A16 Low Road and A151 Holbeach Road,
Spalding – Proposed Site Access Works

Stage 1 Road Safety Audit

Report Title:	A16 Low Road and A151 Holbeach Road, Spalding – Proposed Site Access Works
Report Produced for:	Lincolnshire County Council
Report Dated:	14 April 2026
Document Reference & Revision:	MAL/HRS/RSA1 Rev1
Report Produced by:	Meraki Alliance, Watkin Avenue, Old Colwyn, Conway LL29 9NN Jonathan Birkett 07966296302
On behalf of:	Andrew Moseley Associates

Figure 1: Collision data

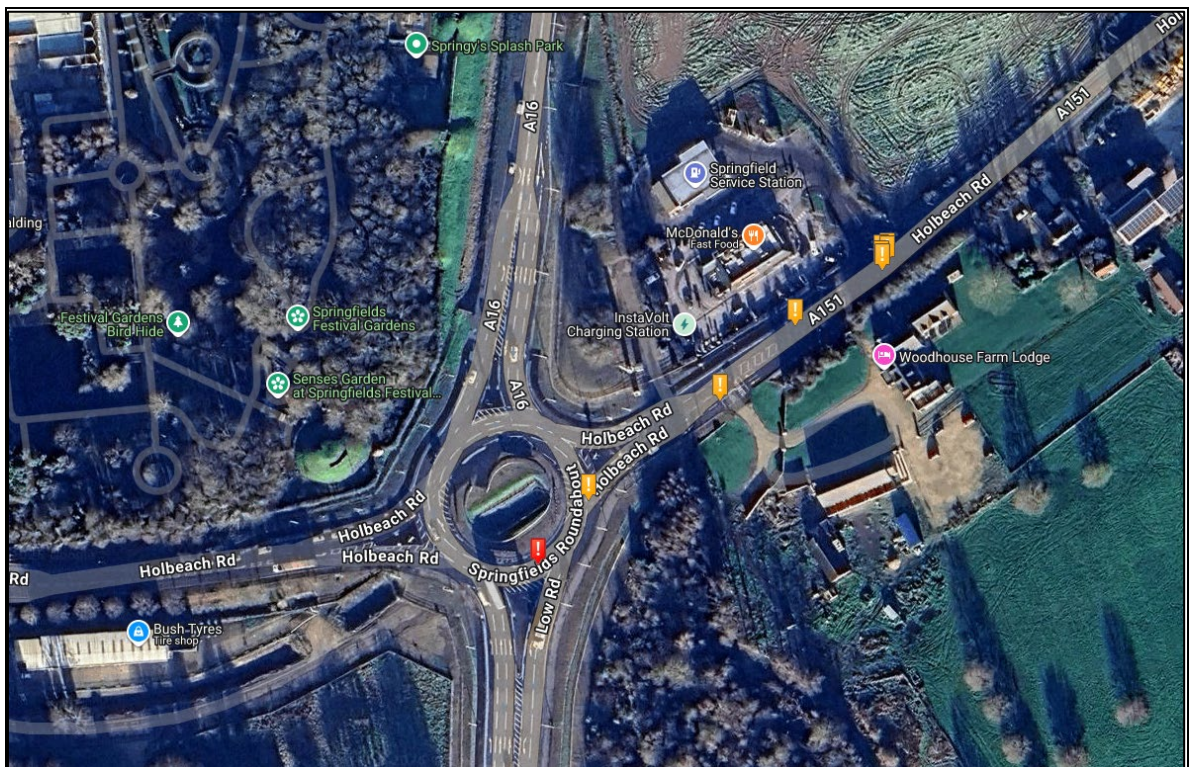
Examination of the data indicates that there has been eight PICs recorded on the A151 Holbeach approach to the Springfields Roundabout and a single collision on the roundabout circulatory. This collision resulted in serious injuries and the collision involved a cyclist.

The eight collisions which all occurred within close proximity to the proposed works, were all recorded as slight in severity. Five occurred at the McDonald's access and were all related to vehicles turning at the access. The remaining three collisions occurred between McDonald's and the Springfields Roundabout with one located near to the existing ghost island right turn that will be altered to form an access into the new development.

Problem Location Plan

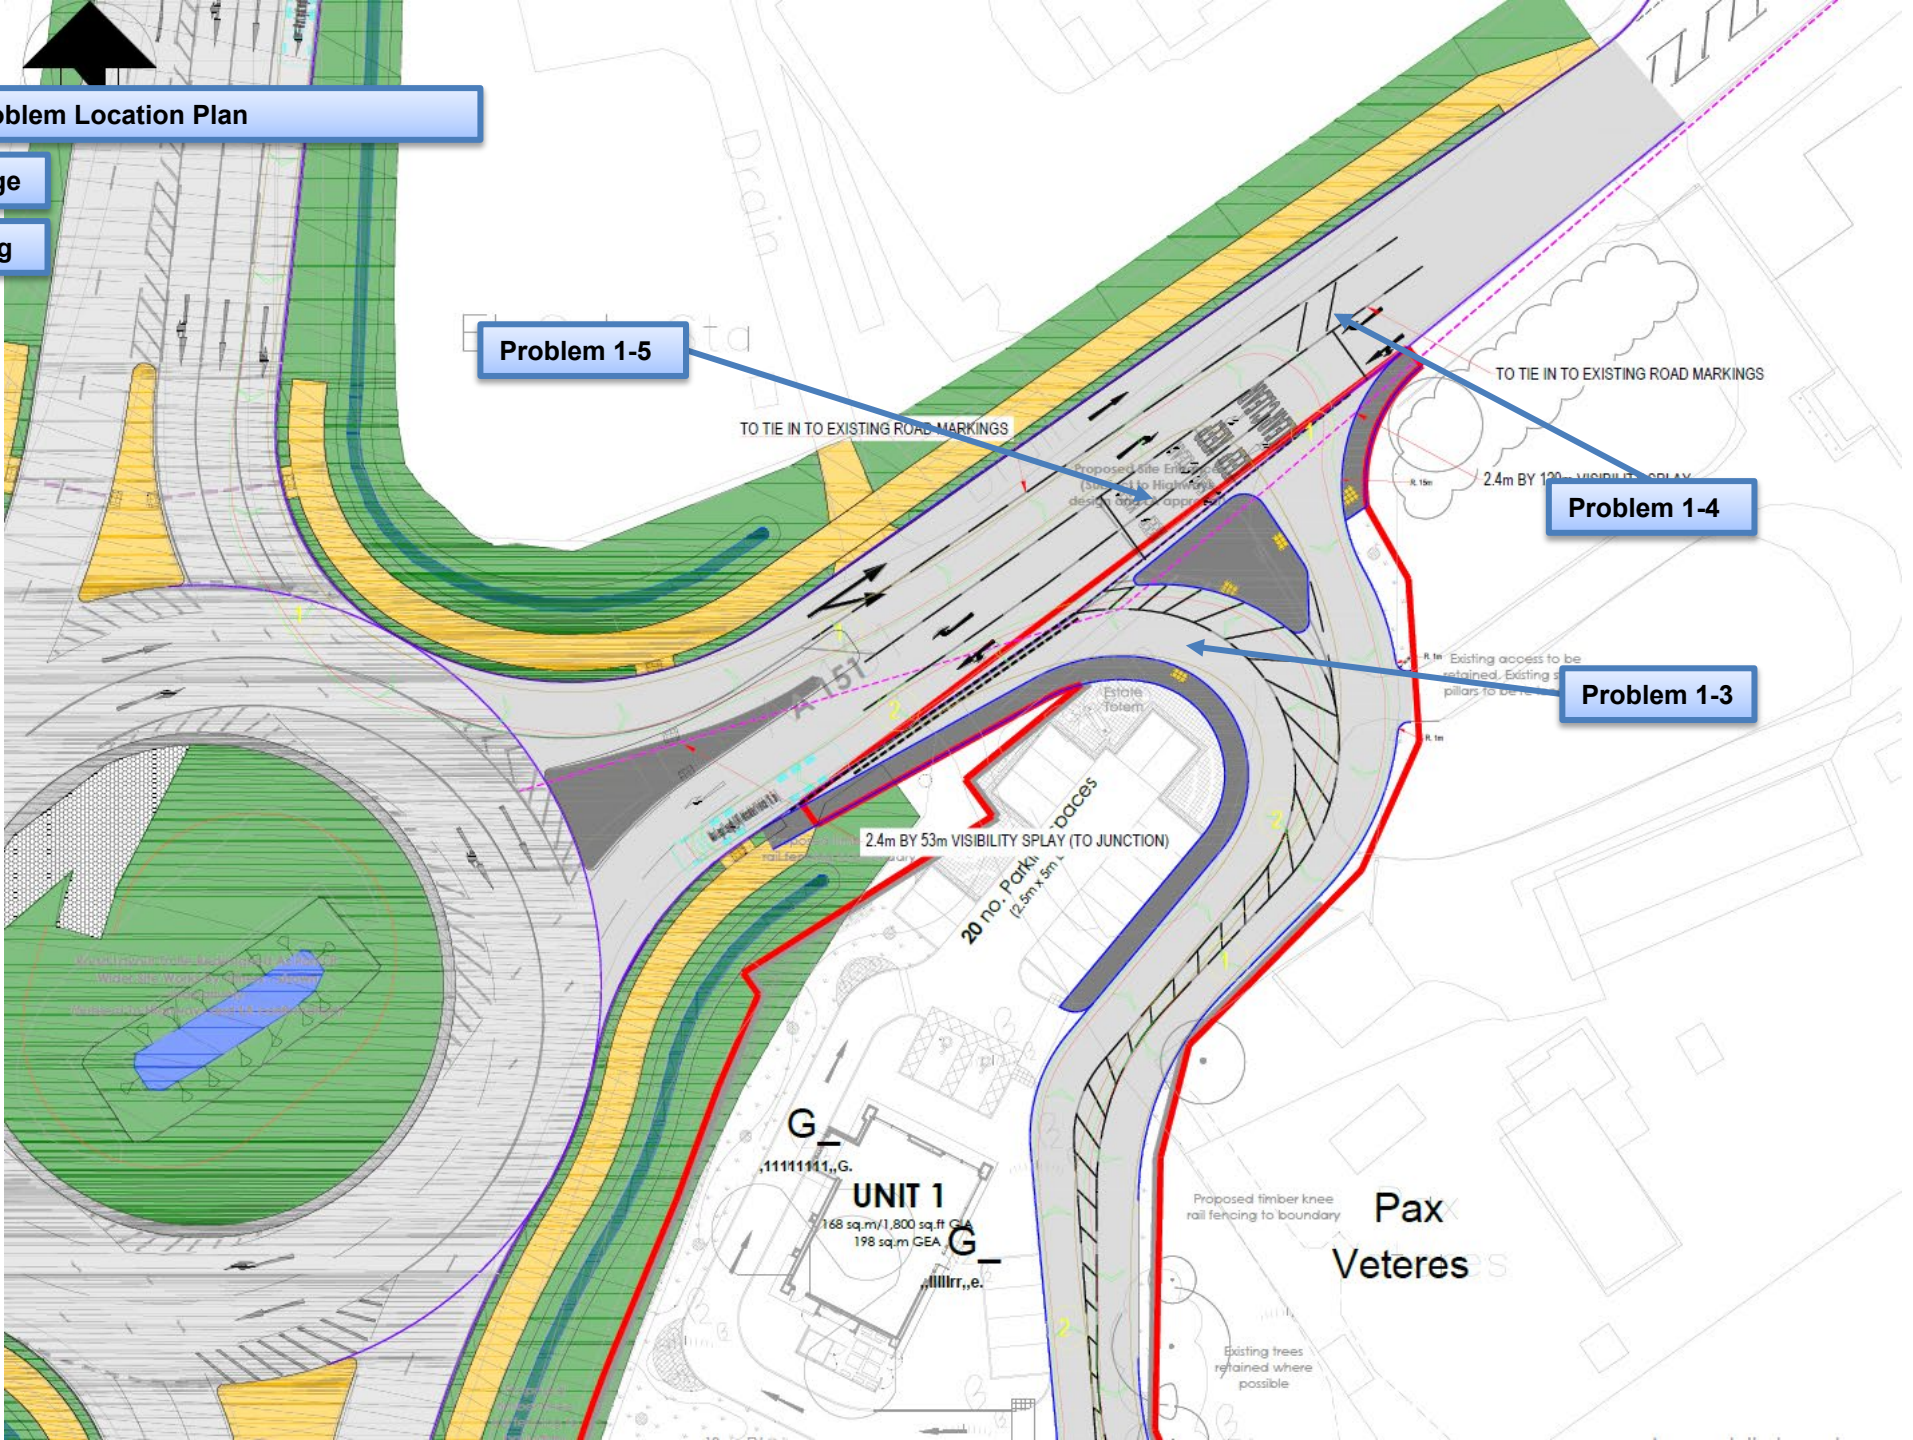
PROBLEM		1-1
Location:	General to the scheme	
Summary:	Increase in collisions resulting from ineffective surface water drainage	
No details of any proposed highway drainage works have been provided as part of the RSA information. The proposals include the alterations and widening of the A151 Holbeach Road and A16 Low Road and will introduce additional impermeable surface. If surface water cannot drain effectively there is a risk of surfacing water ponding and encroaching into the wheel paths of vehicles on the internal highway network. This can result in a loss of friction and subsequent collisions resulting from aquaplaning or loss of control.		
RECOMMENDATION		
Provide effective highway drainage to ensure A151 Holbeach Road can operate safely during wet weather conditions.

PROBLEM		1-2
Location:	A16 and A151 Holbeach Road	
Summary:	Increase in collisions due to insufficient lighting levels	
The proposed junction will a number of the street lighting columns which if not relocated to an appropriate position will result in the accesses and vehicles using it being in shadow during the hours of darkness or low light conditions and could result in an increase in collisions associated with vehicle and pedestrian movements during the hours of darkness. There is also a risk of cyclists and pedestrians being unseen by drivers, as they cross the access junctions or cycle along Holbeach Road and Low Road, resulting in an increase in collisions.		
RECOMMENDATION		
Review the need for street lighting and, if appropriate, include at detailed design.

PROBLEM		1-3
Location:	Site access junction	
Summary:	A lack of signing and lining will increase the risk of cross path collisions	
A new access junction will be created which allows all movements except right turn manoeuvres out of the new development onto Holbeach Road. The drawing provided does not show any signing or road markings that would reinforce this restricted turning movement which could in turn lead to vehicles making a right turn increasing the risk of cross path collisions and head on collisions.		
RECOMMENDATION		
At detailed design include appropriate signing and road markings to reinforce the restricted movements for vehicles exiting the development.

PROBLEM		1-4
Location:	Site access junction	
Summary:	A lack of suitable crossing points will increase the risk of collisions between pedestrians and vehicles on Holbeach Road	
A new uncontrolled crossing is proposed over the development access and a short section of footway around the eastern radius of the access junction. This footway terminates leaving pedestrians with two options, the first to walk in the verge increasing the risk of trips and falls and secondly to cross the A151 Holbeach Road. The drawings do not show any crossing facilities at the A151 and due to the busy nature of Holbeach Road pedestrians will likely have to wait within the central hatched area increasing the risk of being struck by a passing vehicle.		
RECOMMENDATION		
At detailed design carefully consider the need to provide a suitable crossing point of the A151 Holbeach Road to the east of the access junction. Alternatively, depending on demand and desire lines, omit the footway on the eastern radius as well as the proposed crossing point across the junction.

PROBLEM		1-5
Location:	Site access junction A151 Holbeach Road.	
Summary:	Inappropriate carriageway widths and turning radii can result in increased vehicle collisions as well as pedestrian-vehicle collisions.	
Details of the swept paths of vehicles are not provided on the drawing of the A151 junction arrangements. Inappropriate carriageway widths and junction radii can result in vehicles failing to safely negotiate the new junction arrangements and will increase the risk of vehicle collisions and pedestrian-vehicle collisions.		
RECOMMENDATION		
Ensure that the proposed access junction is of sufficient size to accommodate the needs of the development.
